SERVICE LETTER

No. 751

Piper Aircraft Corporation

Fin Front Spar Modification.

FIGURE 2

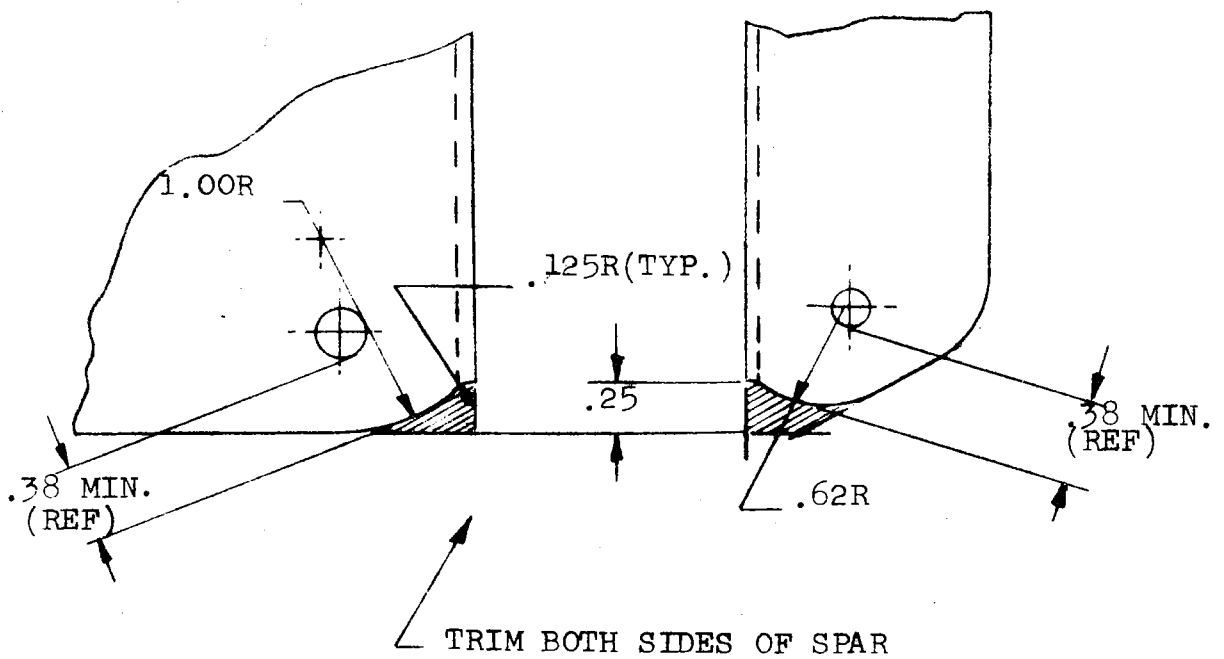
Currently, it is necessary to physically remove the fin to gain visual access to the channel relief holes, as the fin front spar extends over the relief holes by approximately 1/2 to 2/3 of the relief hole diameter.

To eliminate removal of the fin and to enable an easy visual inspection, the fin front spar may be modified in accordance with the sketch/instruction sheet contained on the reverse side of this release.

Refer to "Spar Trimming Detail" on reverse side of this release.

SPAR TRIMMING DETAIL
